July 18, 2017
Medway Planning and Economic Development Board
155 Village Street
Medway, MA 02053

INFORMAL PRE - APPLICATION DISCUSSION – Town of Medway Parks Improvement Project

Park Improvements to Choate Park Cassidy Field, Oakland Park, and Medway Middle School Tennis Court Improvements

Choate Park / Cassidy Field Water Play

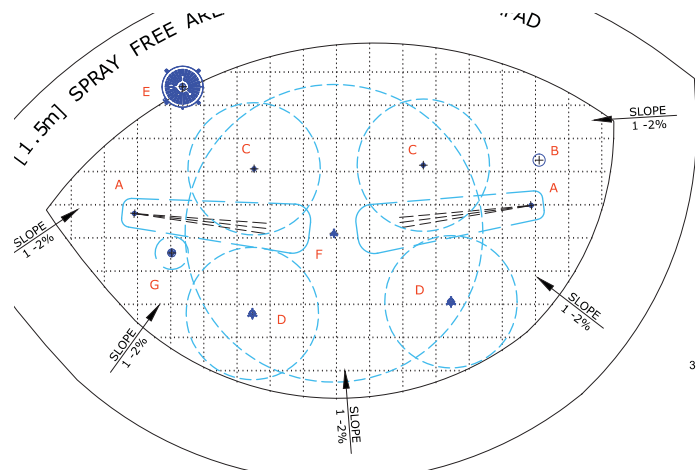
Andy Rodenhiser asked if water will be recycled.

Bob Tucker expressed concern about water usage. How can the Town have this water feature and then not allow residents to hand water on their property?

Andy Rodenhiser asked about the location of the above ground box for the recycling equipment for the water splash area.

Rachel Walsh noted seems ludicrous to have a splash area that doesn't reuse water when the Town has water restrictions.

A question was asked about how the water works. Does it run continuously? Is it button activated?

Jessica Chabot asked if rain water could be collected and reused for the water feature.

Andy Rodenhiser asked about drilling a well and using that for the splash pad.

Clara Batchelor noted that there needs to be a lot more infrastructure to recycle water. It has to be treated. It costs about \$120,000 more in initial outlay to do a water recycling system. This involves an underground water storage tank and a small outbuilding for some equipment.

Clara Batchelor reported that a water play feature was strongly requested in the survey and public meetings. The EPFRAC team has not yet decided whether to have recycled water. Operating and maintenance costs of water play area are relatively low. It was operate from Memorial Day to Labor Day and can be readily handled by DPS staff.

Clara Batchelor responded that the equipment would be near the pad.

Clara Batchelor stated that the splash pad is a given. The option is whether or not the water is recycled.

DJ Chagnon reported that when they looked at actively used park in downtown Somerville, the water feature ran about 15 minutes out of every hour.

Clara Batchelor reported that rain water is grey water and that could be used for irrigation, but not for the splash pad.

Clara Batchelor stated that water for a splash pad has to be potable.

DJ Chagnon reported that they had discussed the well idea with Dave D'Amico. Dave didn't think it made sense to drill a well.

Choate Park / Cassidy Field
New Pavilion Information

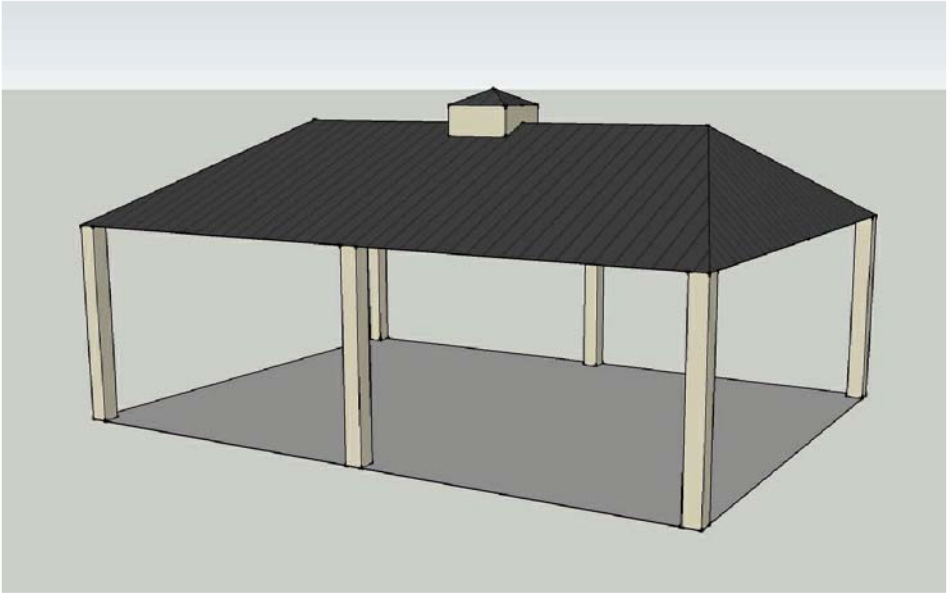
Matt Buckley indicated the DRC would be glad to provide some input on the pitch of the gable pitch.

Seth Kendall noted it would be nice if the colors of the pavilion and the playground equipment could reflect New England village character and enhance the natural New England feel with a different color palette, something that would not fight with the trees.

Clara Batchelor reported that there are various color options. The EPFRAC team preferred greens and browns. The green wouldn't be neon but fairly close to new leaves on trees. We really did work with the committee to find colors in nature.

Choate Park / Cassidy Field Pavilion Example Images

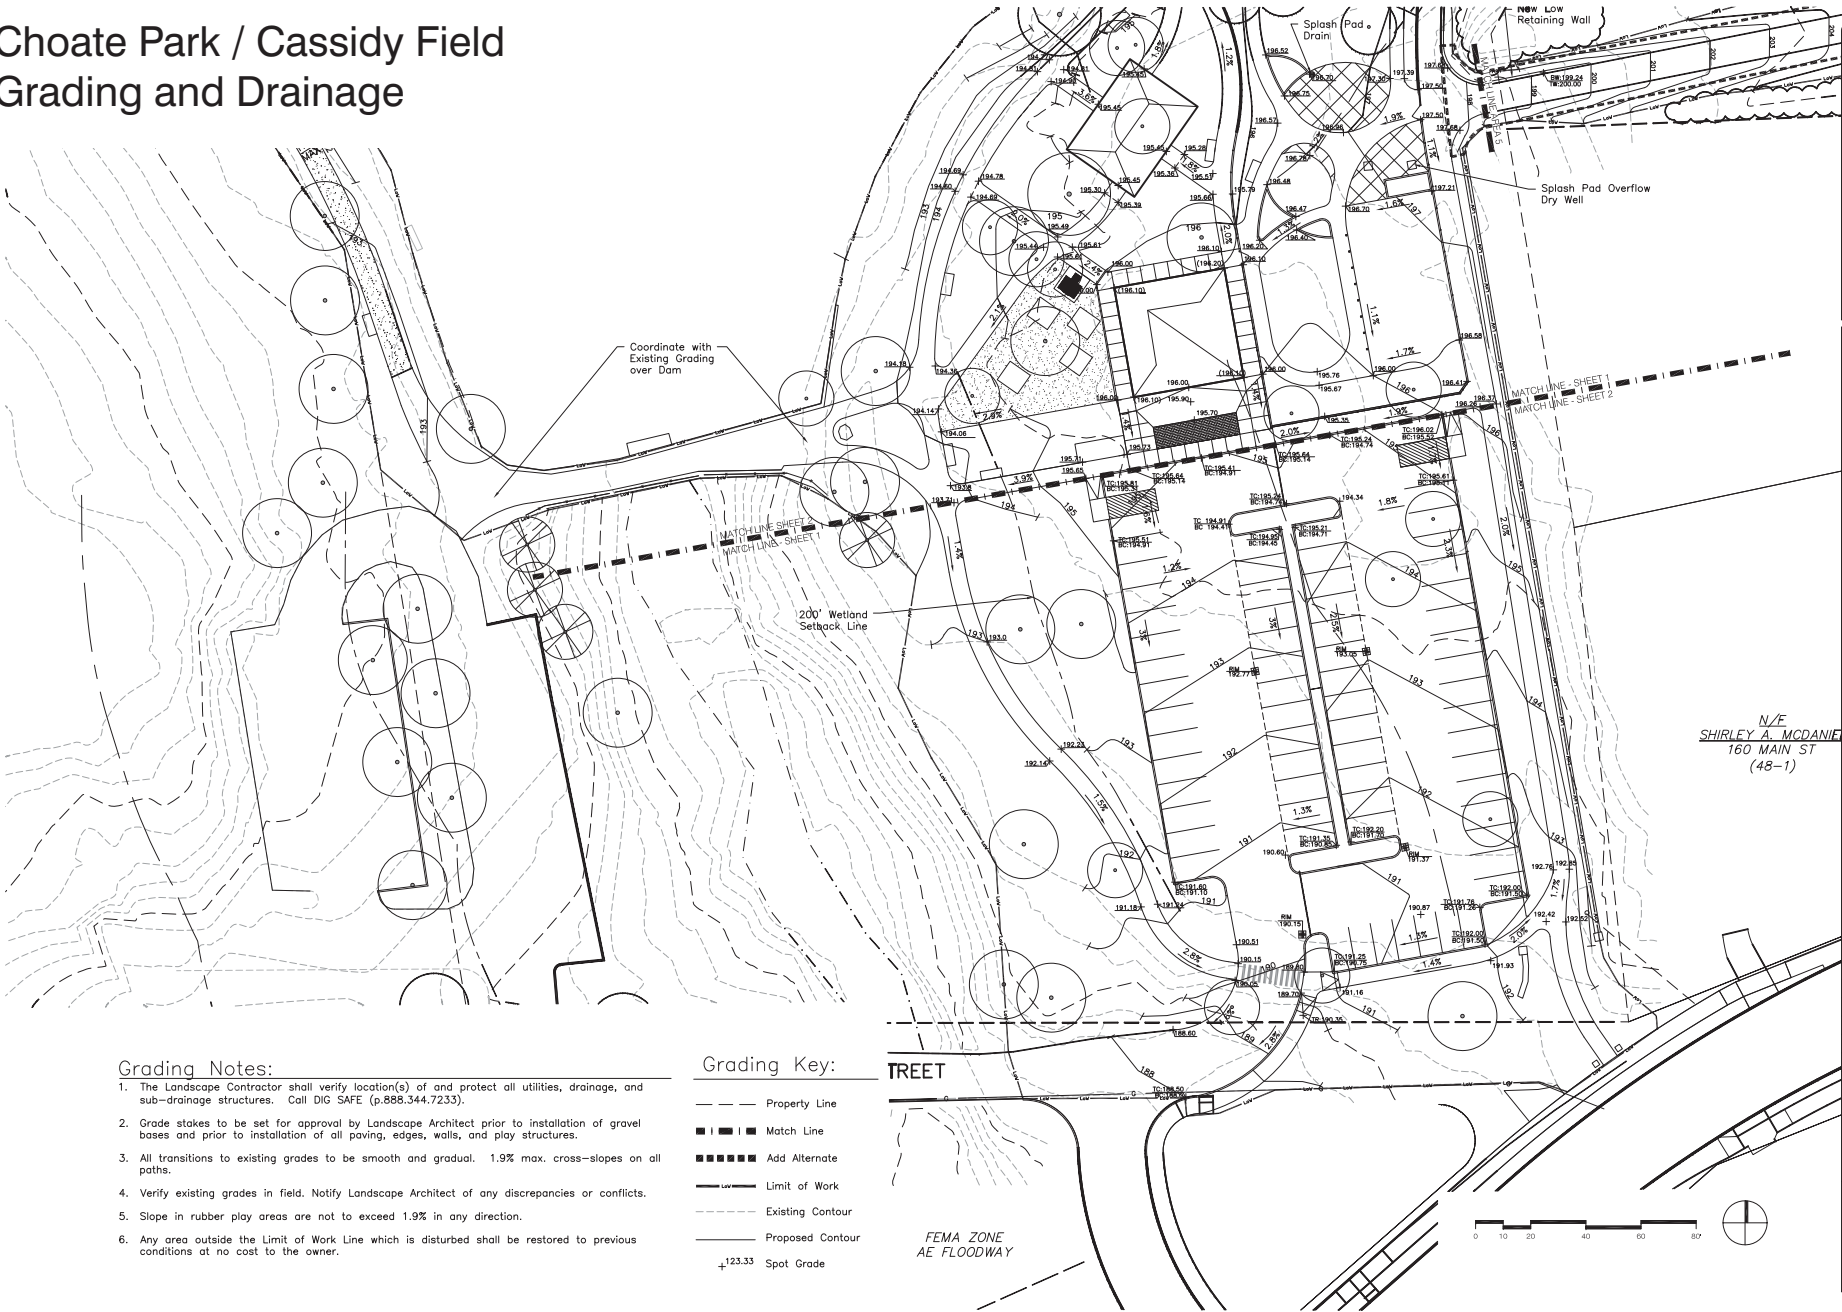
Rachel Walsh commented that this pavilion at Choate should look like this and would better fit to Design Review Guidelines

Matt Buckley indicated that a timber structure is more in keeping with Thayer.
